# RAIL COACH FACTORY, KAPURTHALA

**CAI N O.: ED/CAI/027 Dated: 27.12.2023**

# COACH ALTERATION INSTRUCTION SHEET FOR MODIFICATIONS IN EXISTING LHB NON AC GS TYPE COACHES

This Coach Alteration Instruction Sheet has been issued for modification in existing **LHB Non AC GS type coaches** wherein following steps are to be taken for modifications in the coach:

| WELD LENGTH | ITEM | DESCRIPTION & DIMENSIONS | QPASSLT | DETAIL DRG | MATL. & SPEC. | REMARKS |
|---|---|---|---|---|---|---|
| HEIGHT | | | | | DRG.NO. | SKED-927 |

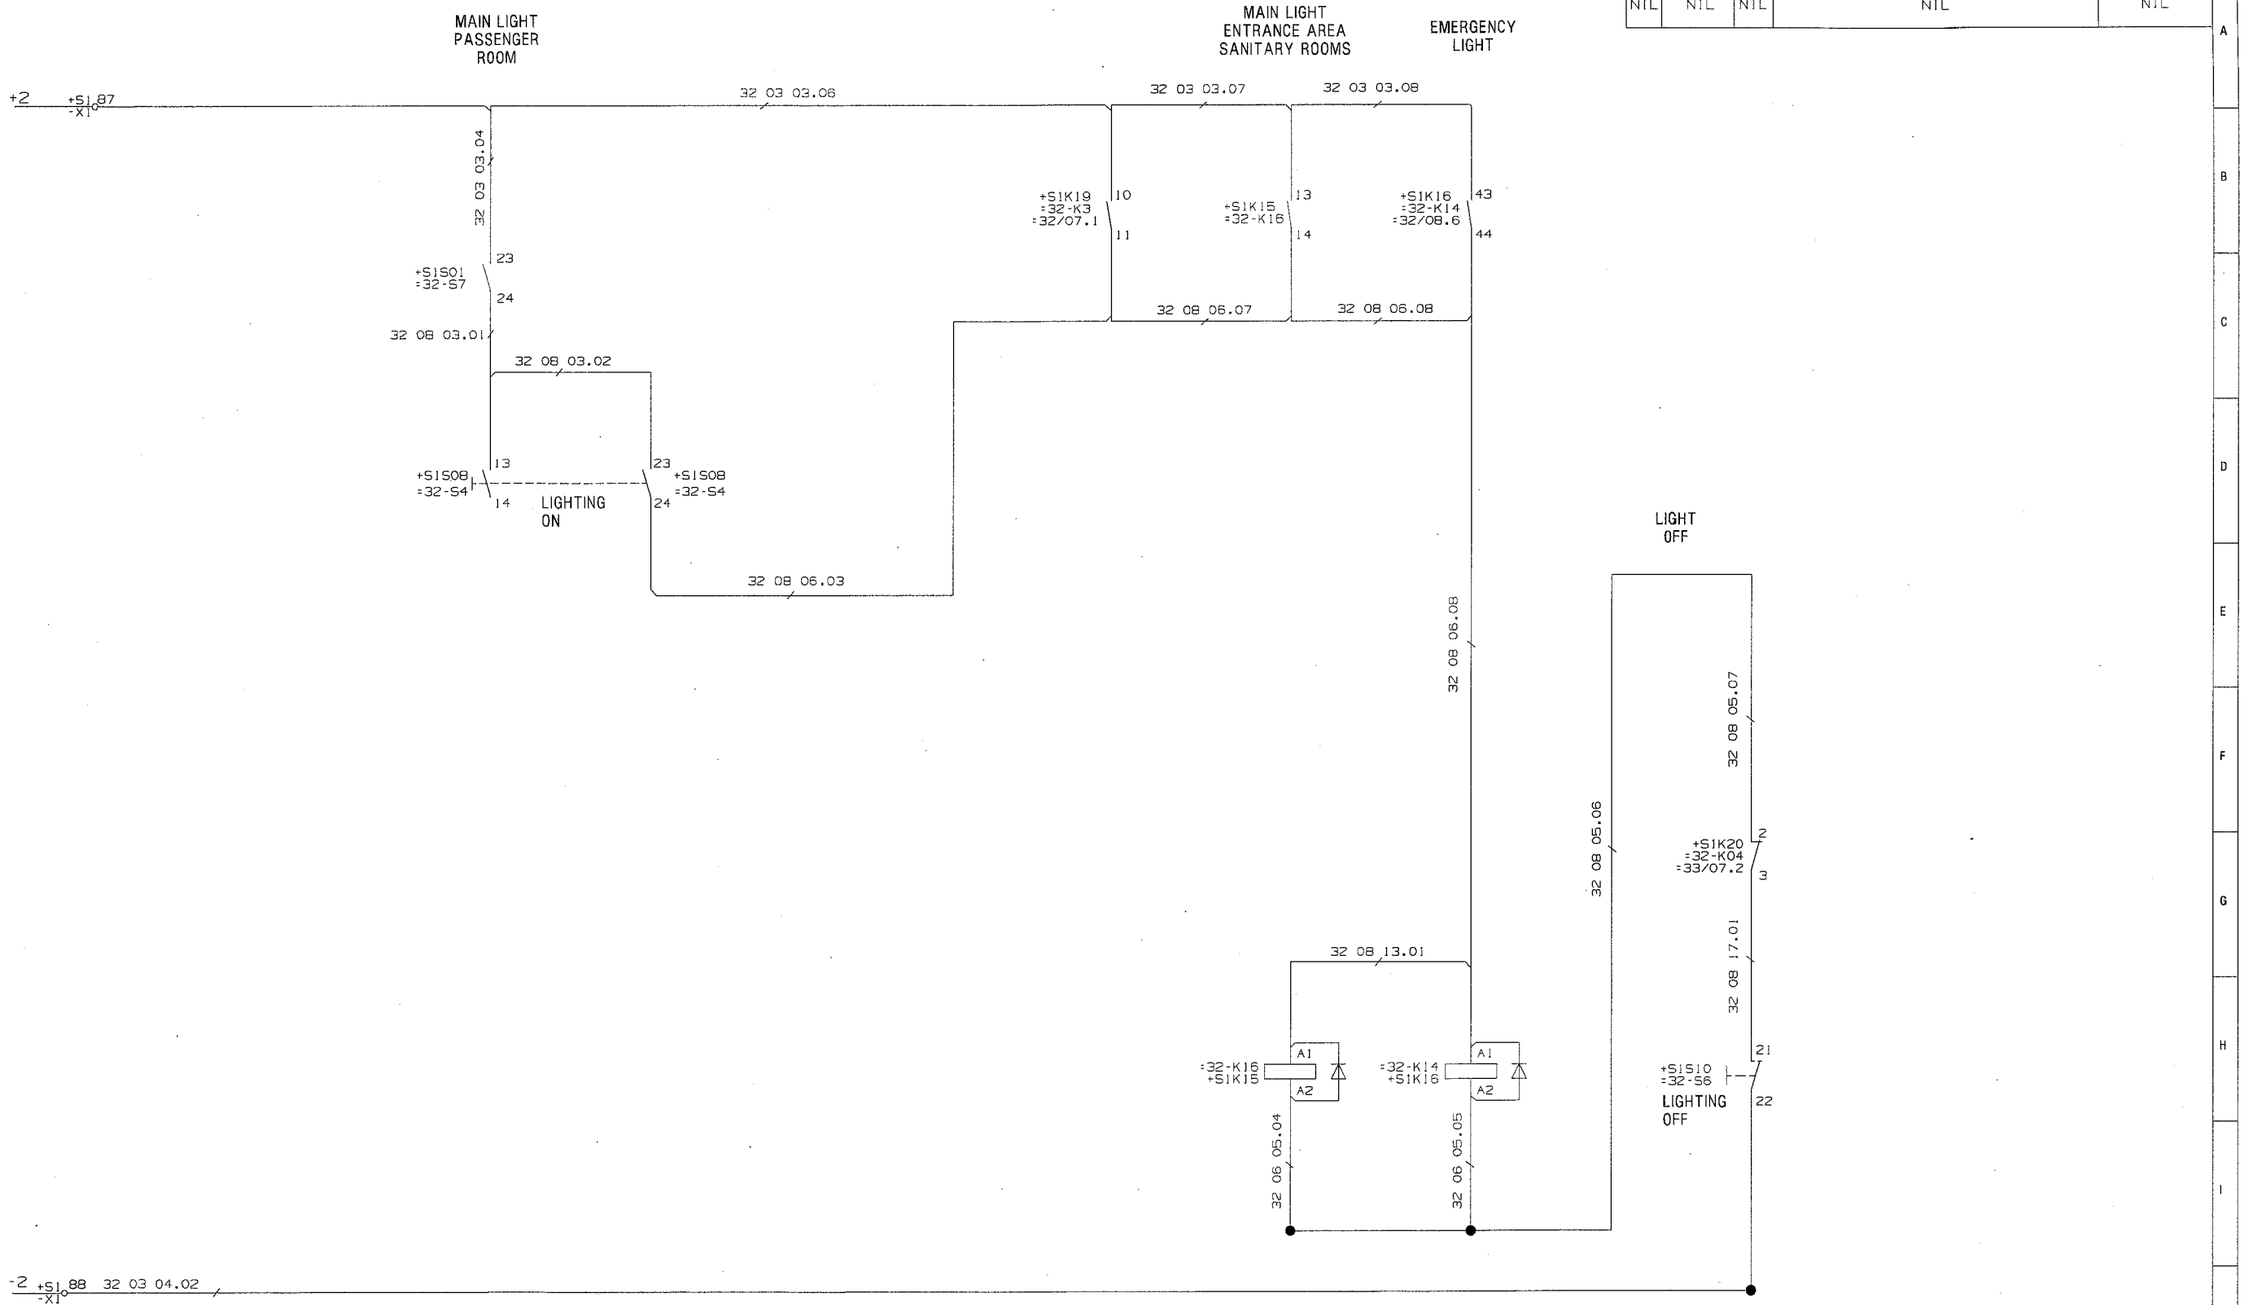
| Changes in the Switchboard Cabinet to Spec no EDTS333 | | |
|---|---|---|
| **A.4** | **Drawing no LS70202 sheet 4/13 revised to drawing no SKED 927** | |
| | 1 | Transformer 33T01/+S1F74, 1 kVA 230/110 volts deleted |
| | 3 | MCB 33F22/S1F39, 33F23/S1F40, 33 F24/S1F41 deleted |
| | 4 | Insulation Monitoring Relay 93A1/S1A06 deleted |
| | 5 | Wago type Fuse 33F35/S1F74 and 33F36/S1F75 marked spare |

## REVISED TERMINAL BLOCKS

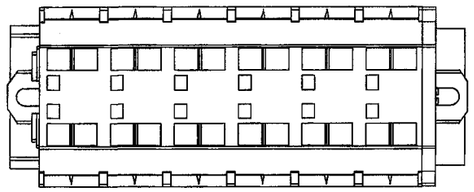
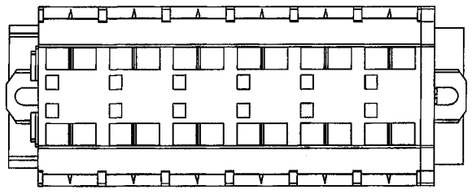
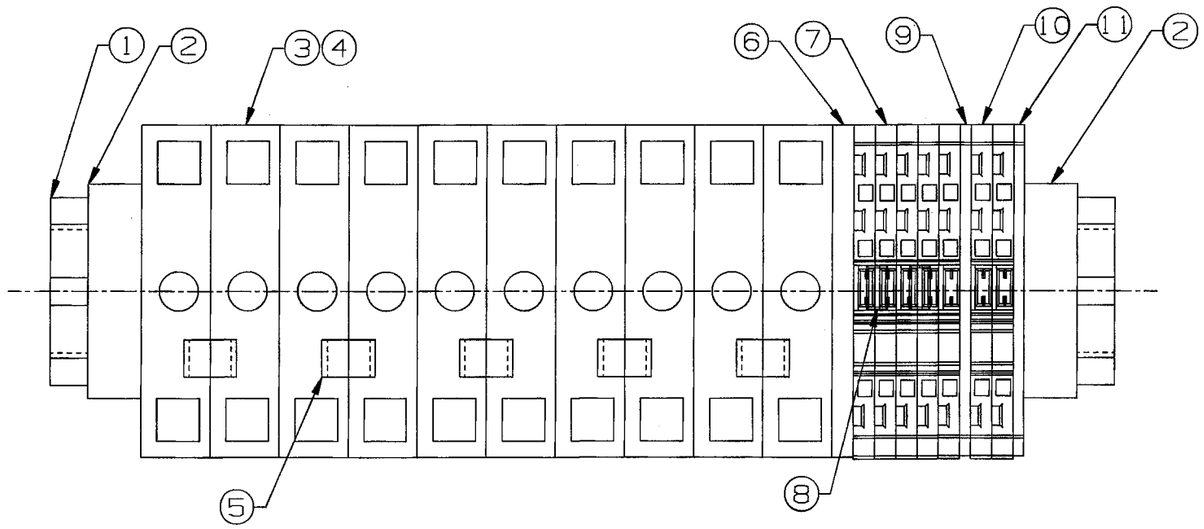
i. Cage clamp terminals with glass fuses as per drawing **SKED 933** shall be mounted on the existing bracket in each cabin on both side of the cabin area with the aid of suitable hardwares .

| D | Modifications in the Structural drawing of the SBC : | |
|---|---|---|
| | 1 | Terminal no. 83 to 86 changed to 280-837 of M/s WAGO in-place of 280-833 of M/s WAGO |

## REVISED TERMINAL BLOCKS

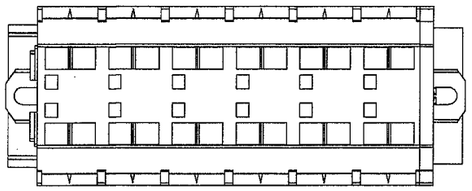
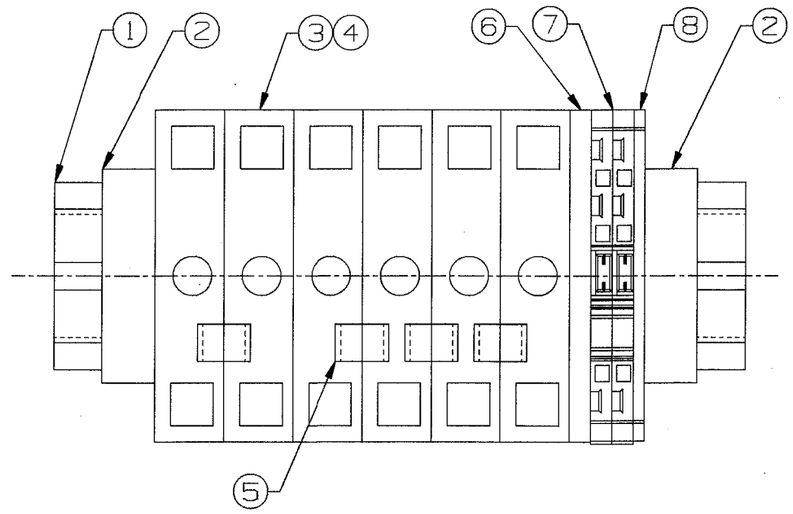
ii. Cage clamp terminals with glass fuses as per drawing **SKED 934** shall be mounted on the existing brackets in each doorway area on both side with the aid of suitable hardwares

# MCB HOLDER
## FOR SWITCH BOARD CABINET

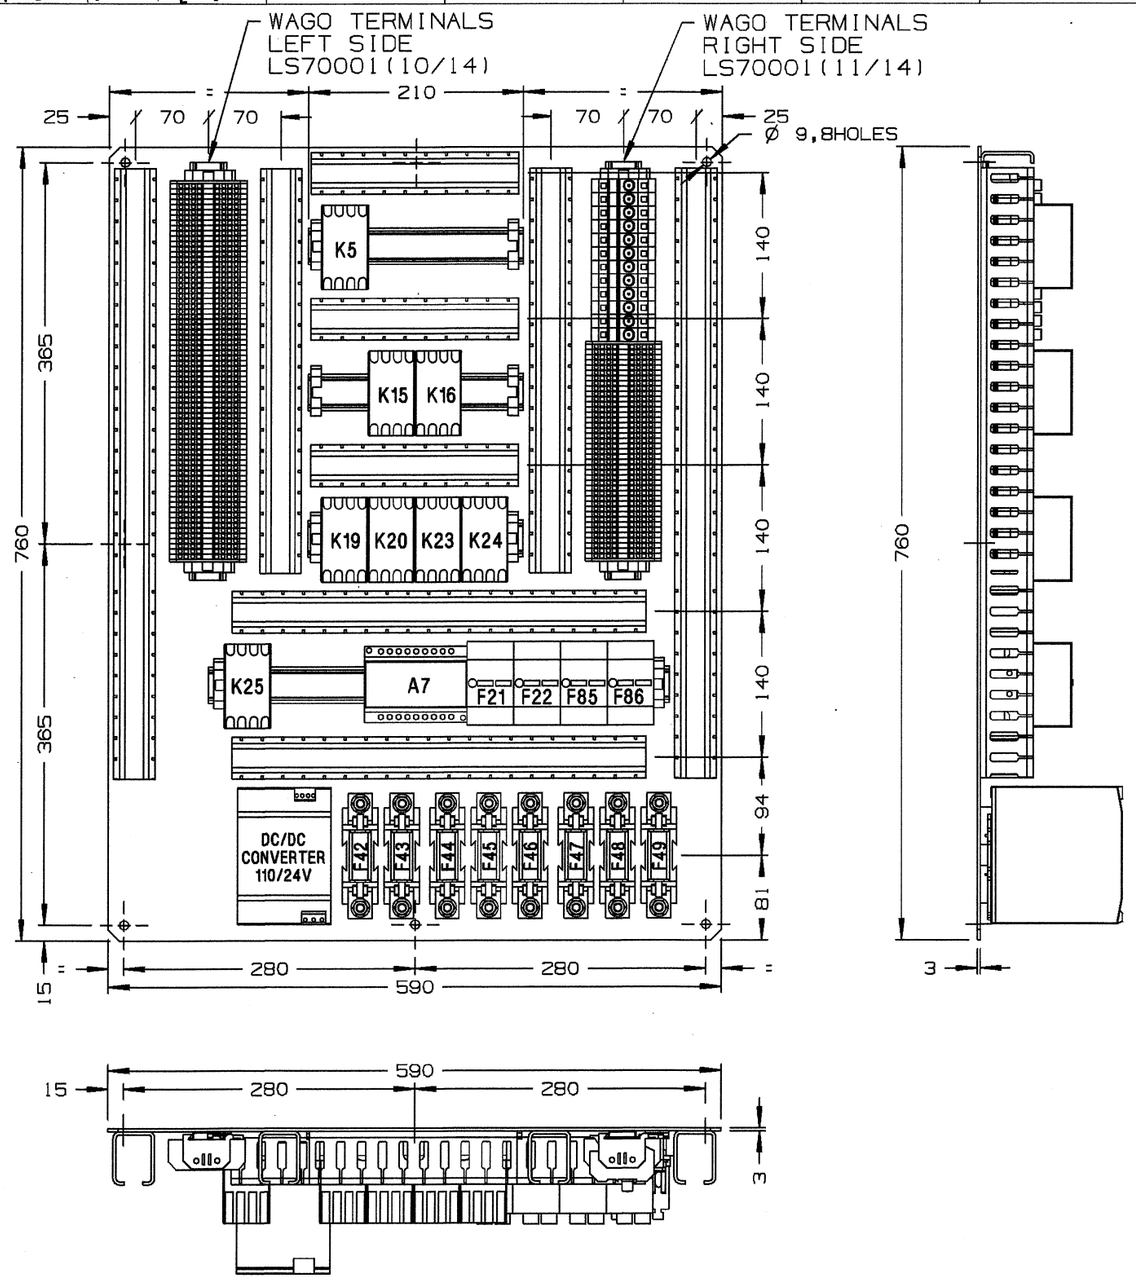
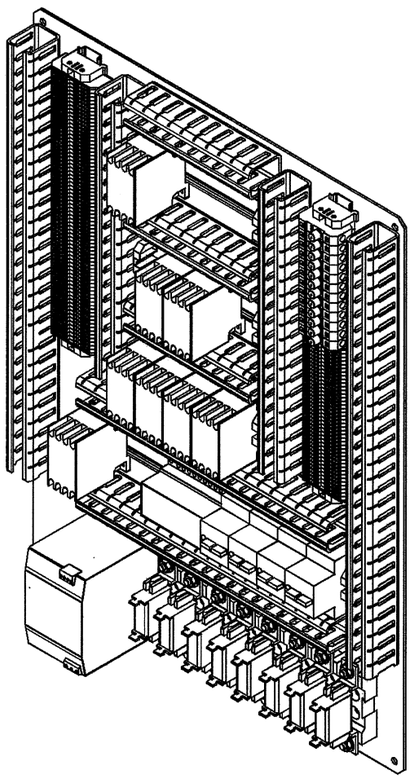
| D | Modifications in the Structural drawing of the SBC : | |
|---|---|---|
| D.1 | **Drawing no LS70201 sheet 3/14 Revised to drawing no SKED 935 sheet - 1** | |
| | 1 | Contactors 32K10/+S1K11, 32 K12/+S1K14, 32 K13/+S1K13, 32 K15/+S1K17, MR9, 110 V 32U3/+S1U2.3, 32K05/+S1K08 deleted, drawing revised |

NOTE:- 1. ALL DIMENSIONS IN MM.
2. REF. DRG. NO.LS70201 (SHEET-3/14).
3. S1K11,S1K8,S1K13,S1K14,S1K17,S1K48 & S1A6 DELETED.
